AMENDMENTS TO THE DRAWINGS

Figure - 9c

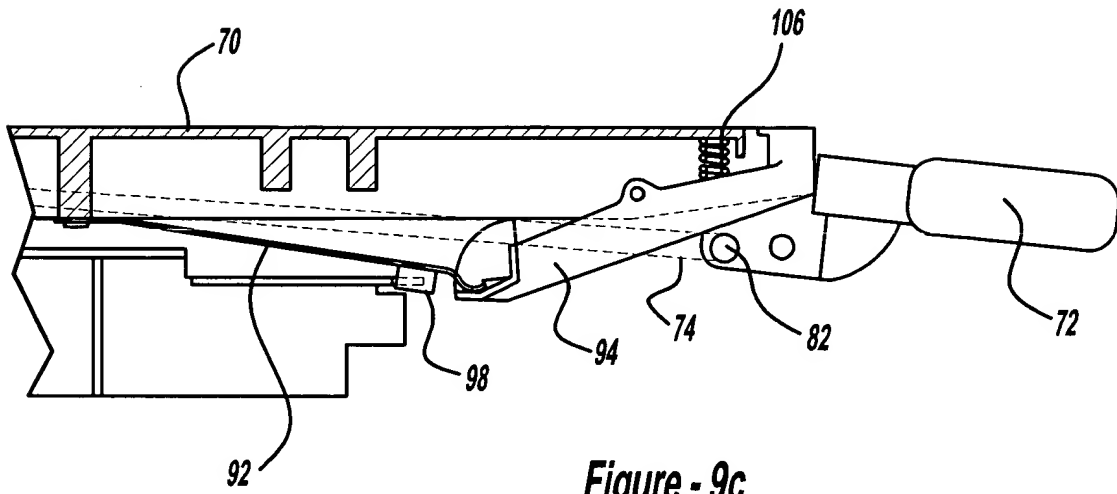
The attached "Replacement Sheet" of drawings includes changes to Figure 9C. Please amend Figure 9C by revising the position of lever 94. Please add new Figure 9D. The attached "Replacement Sheet," which includes Figures 9C-9D, replace the original sheet including Figure 9C.
